US 27/SR 1 - HAMILTON ROAD WIDENING
Project No. NH-017-1(20)
P.I. No. 322250
Troup County

Value Engineering Study Report
Preliminary Design Submittal

December 2007

A-9
Sht. 2 of 9
Original Design

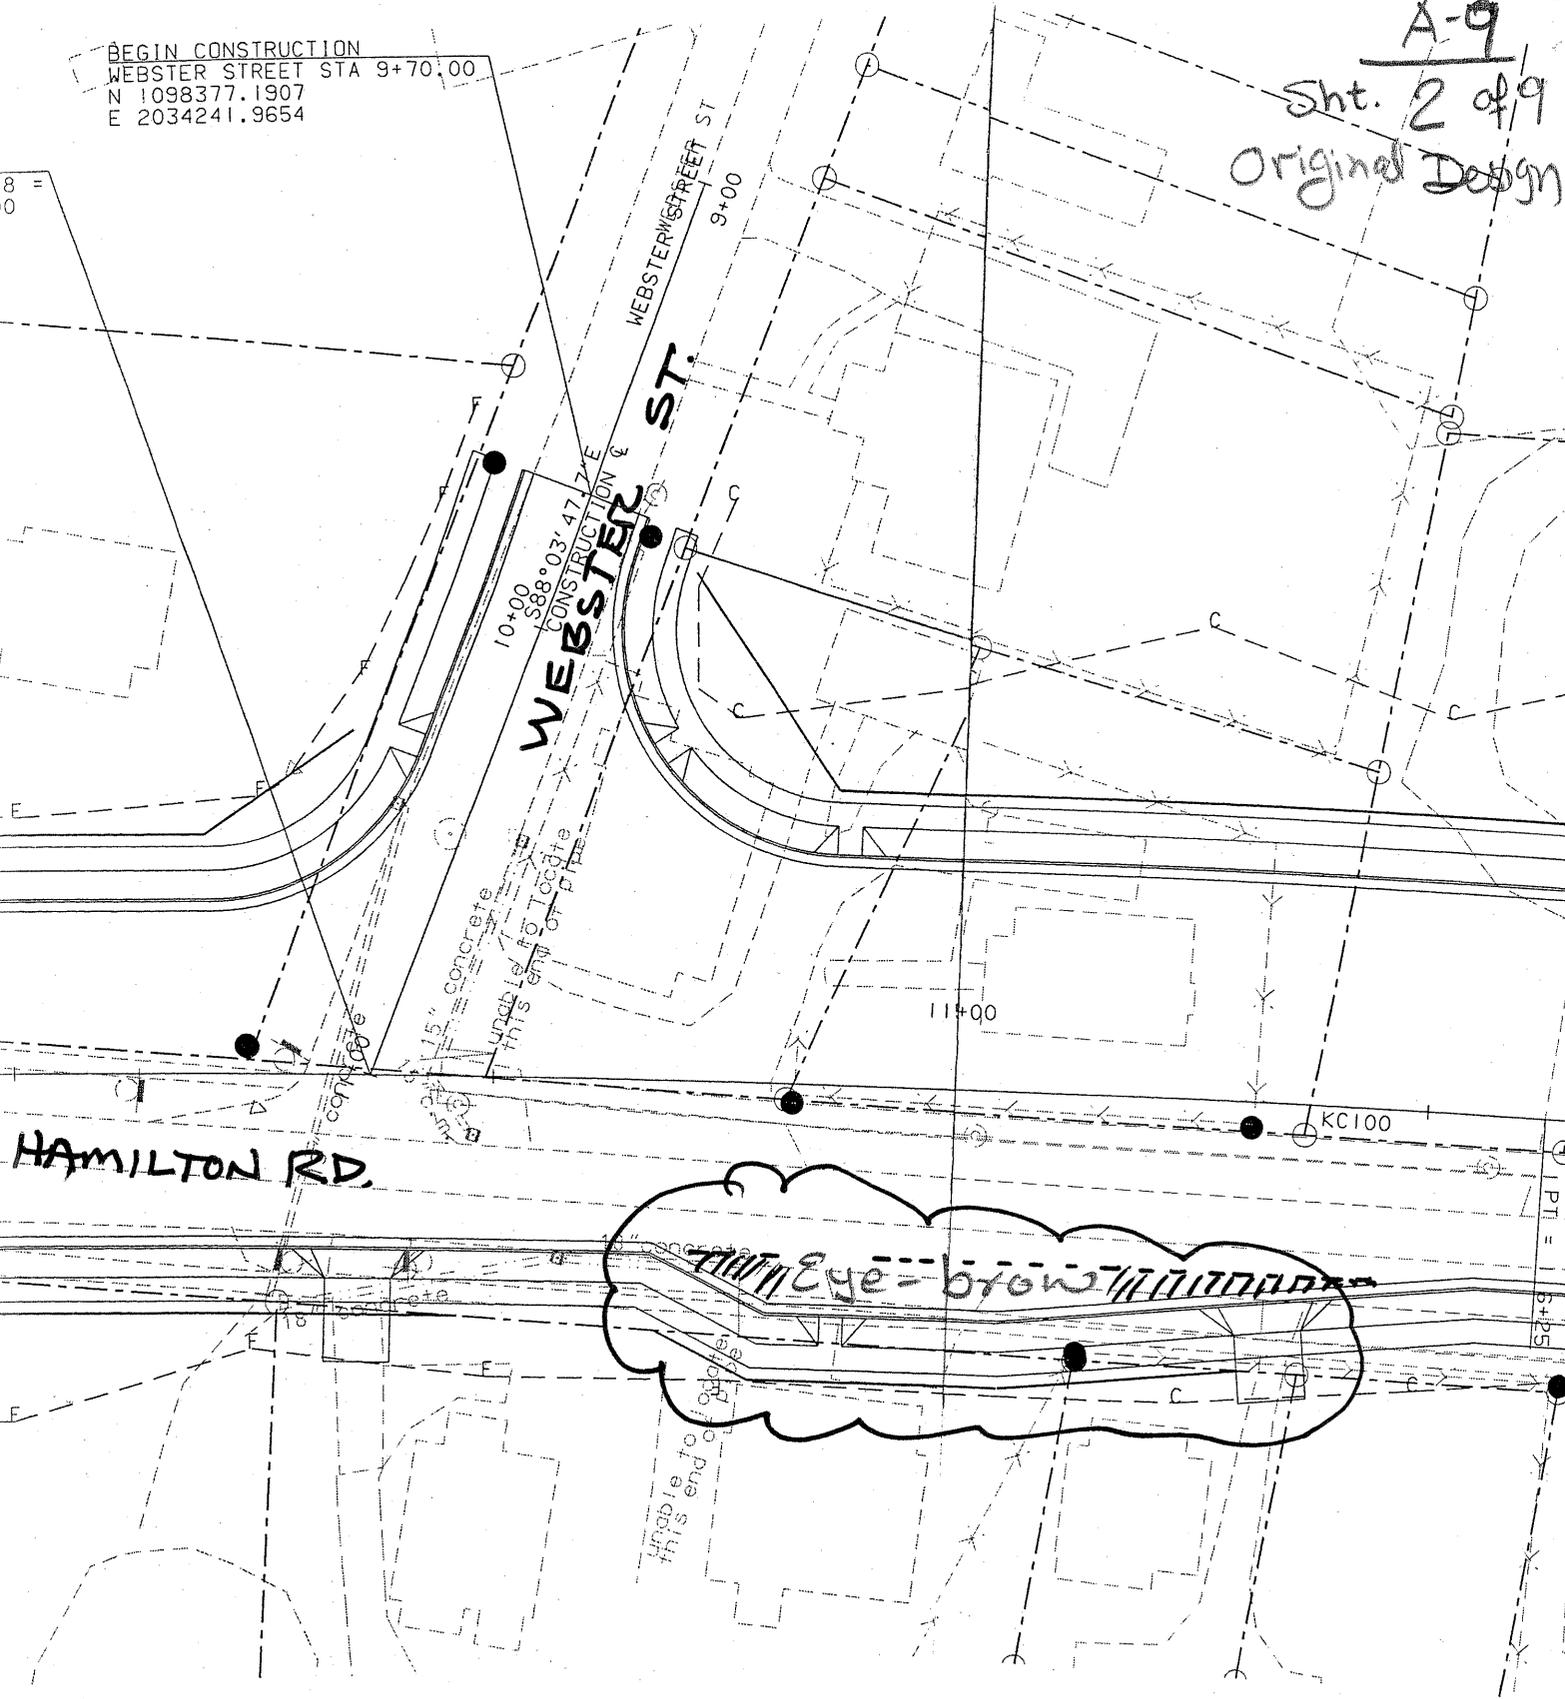
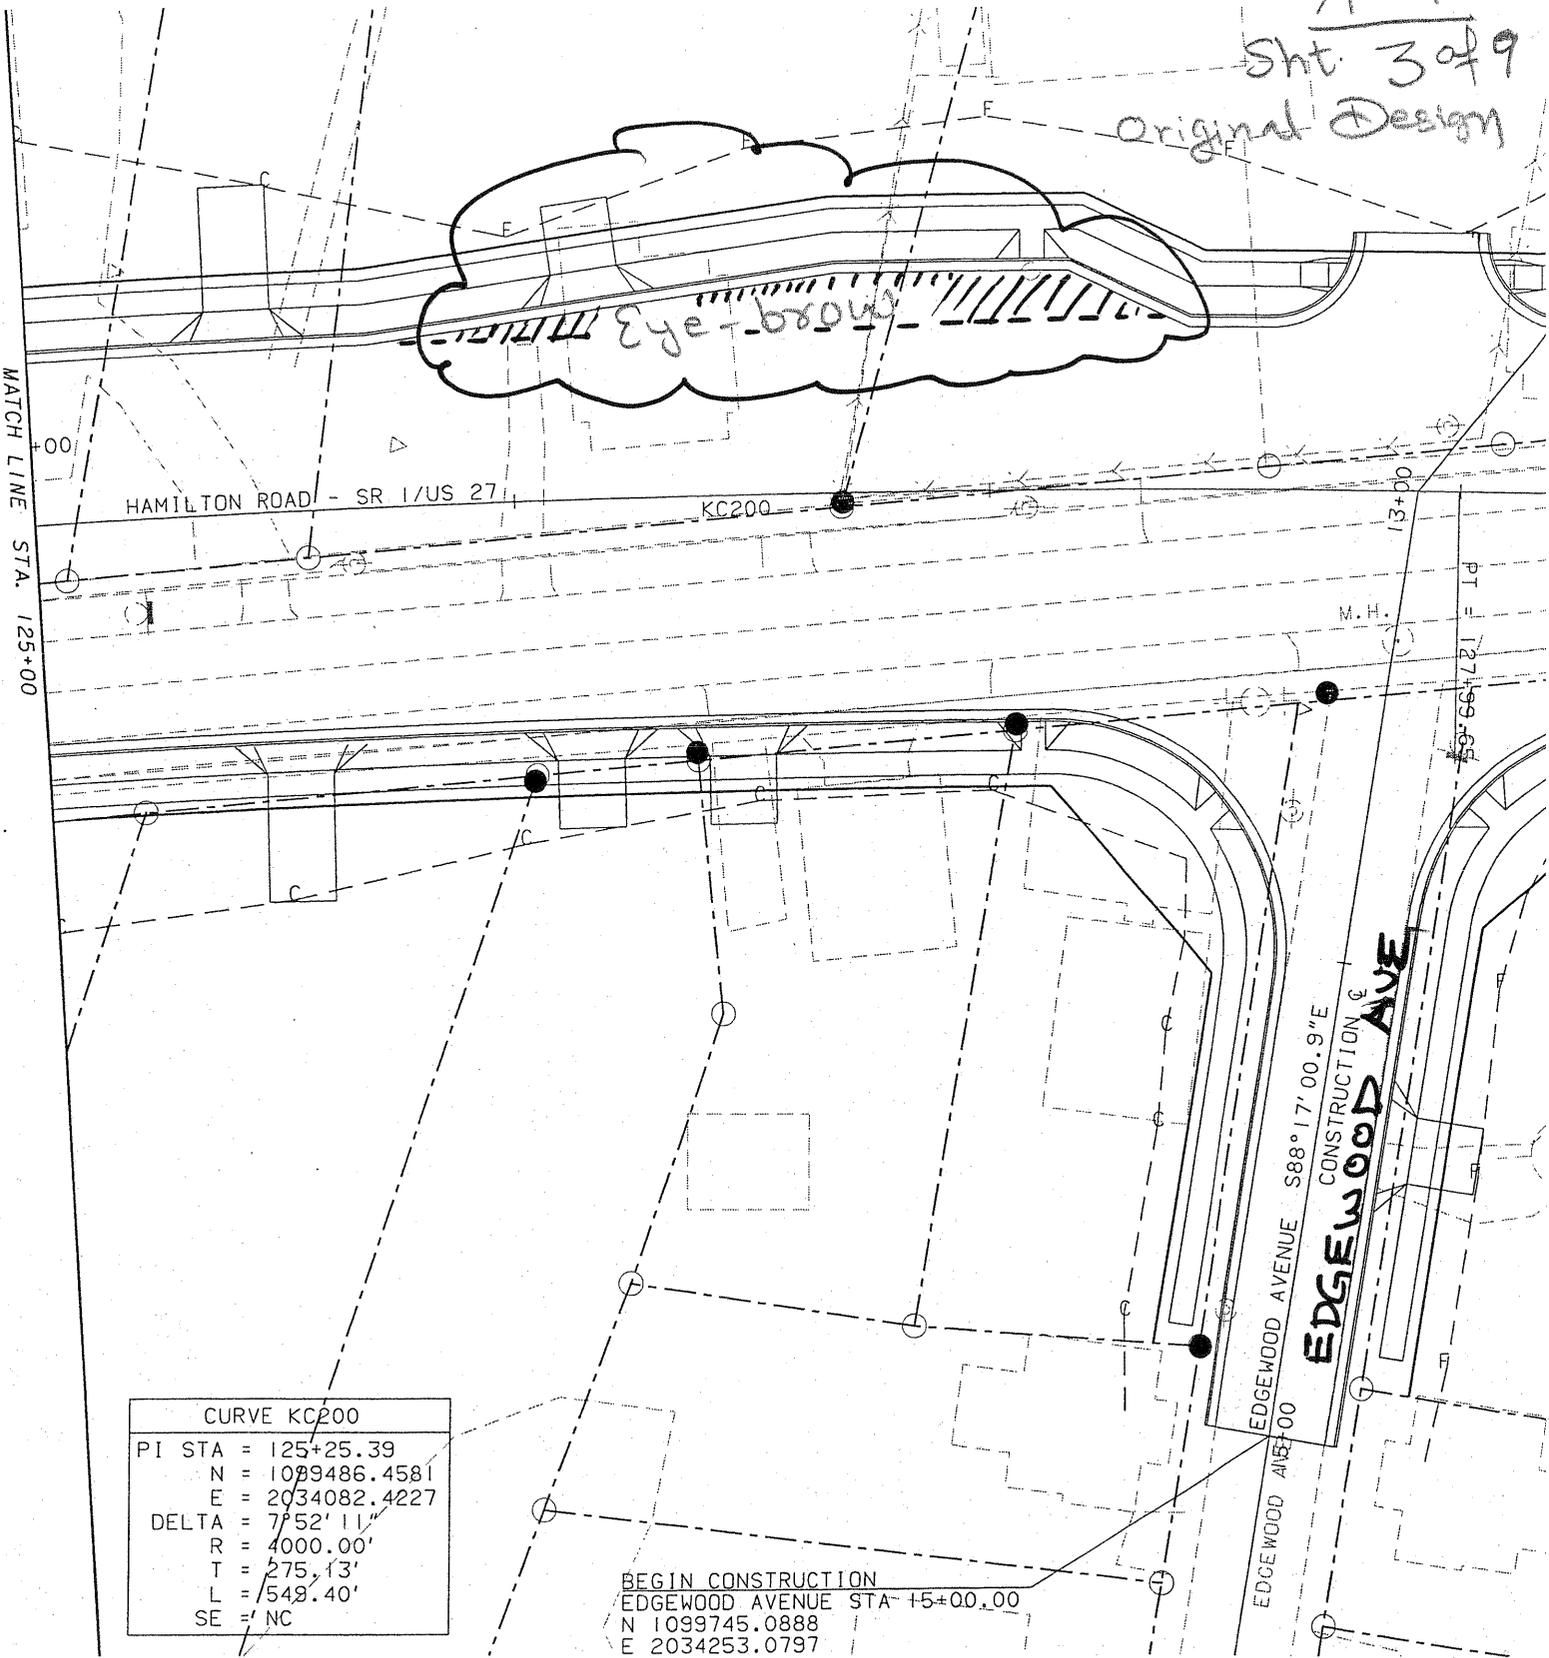
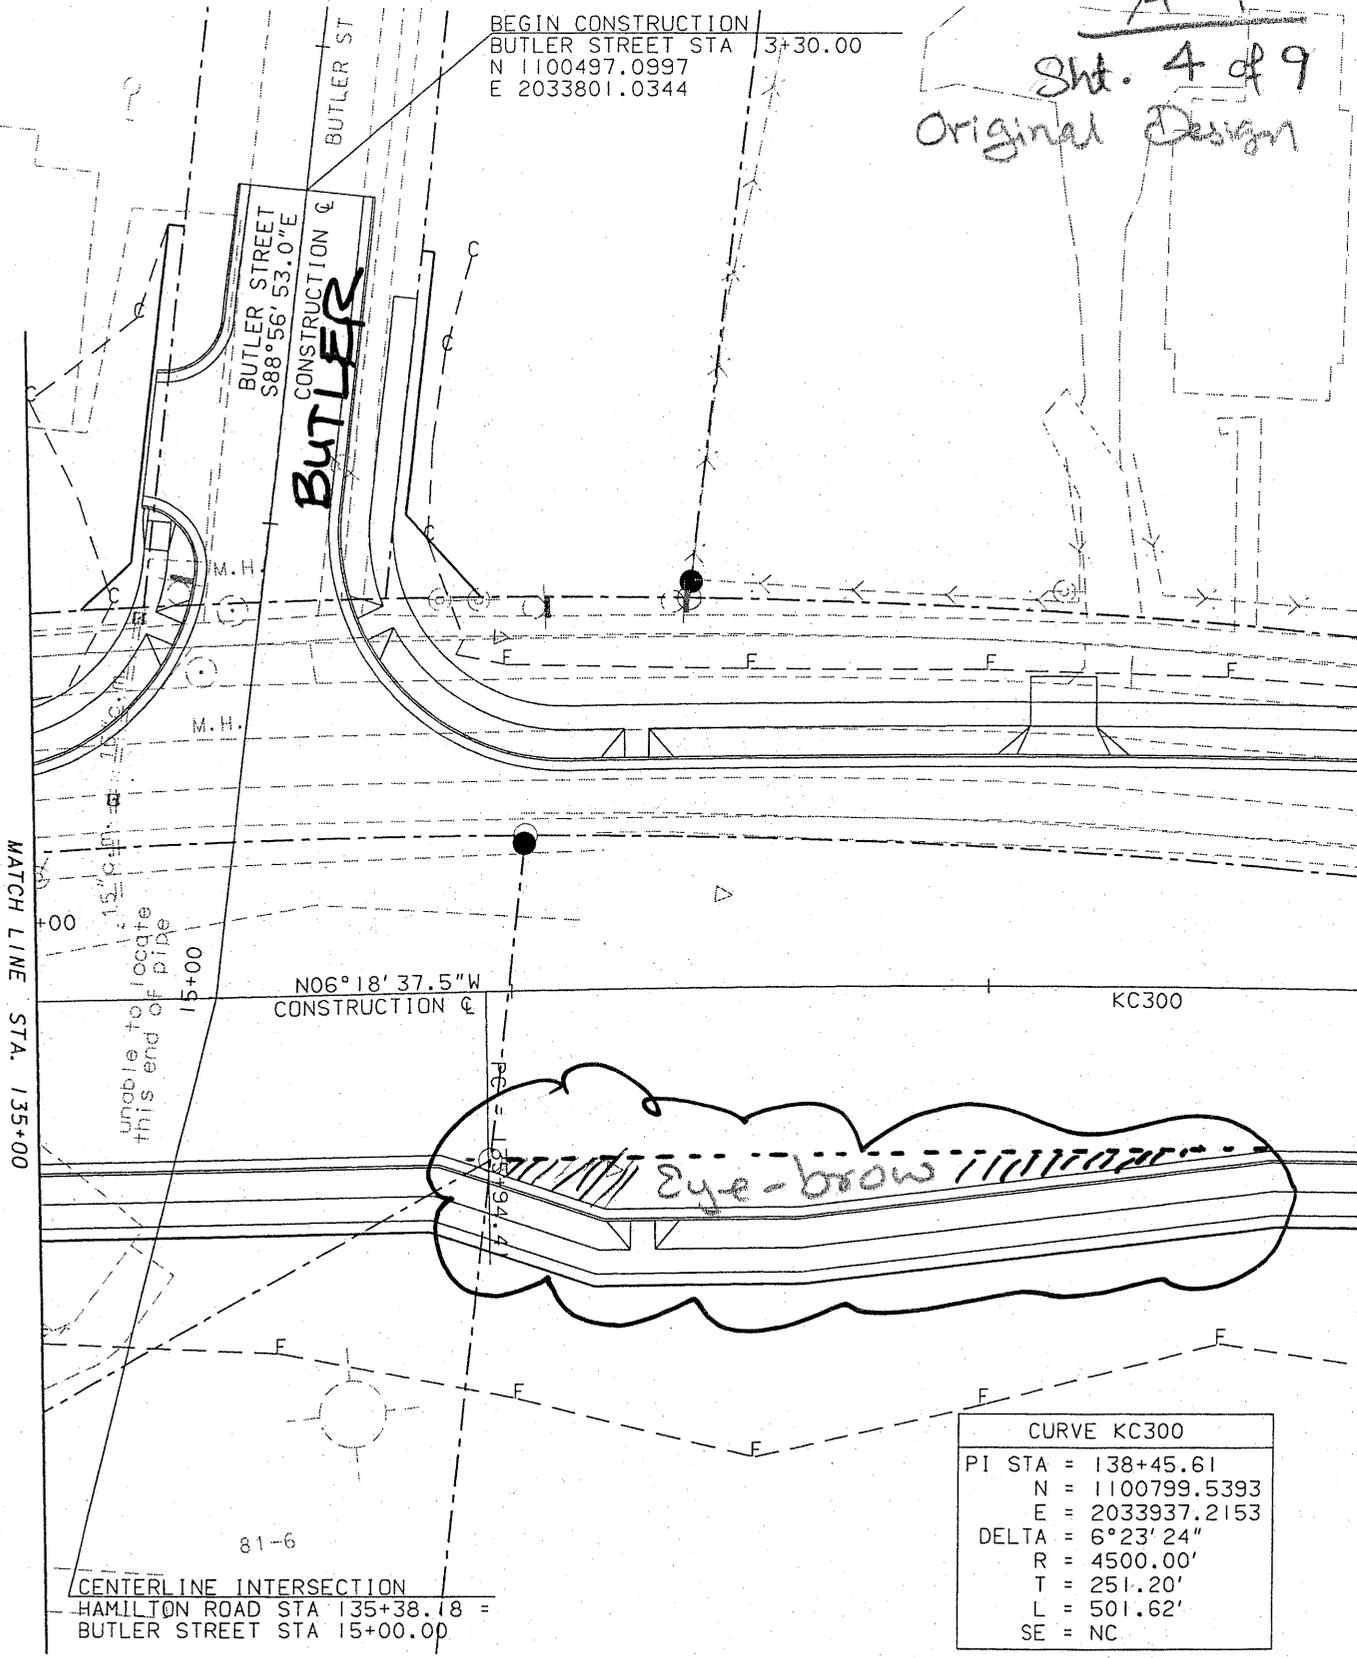
Remove the eyebrows on Hamilton Road opposite Webster Street, Edgewood Avenue and Butler Street. Continue curb, gutter and sidewalk.
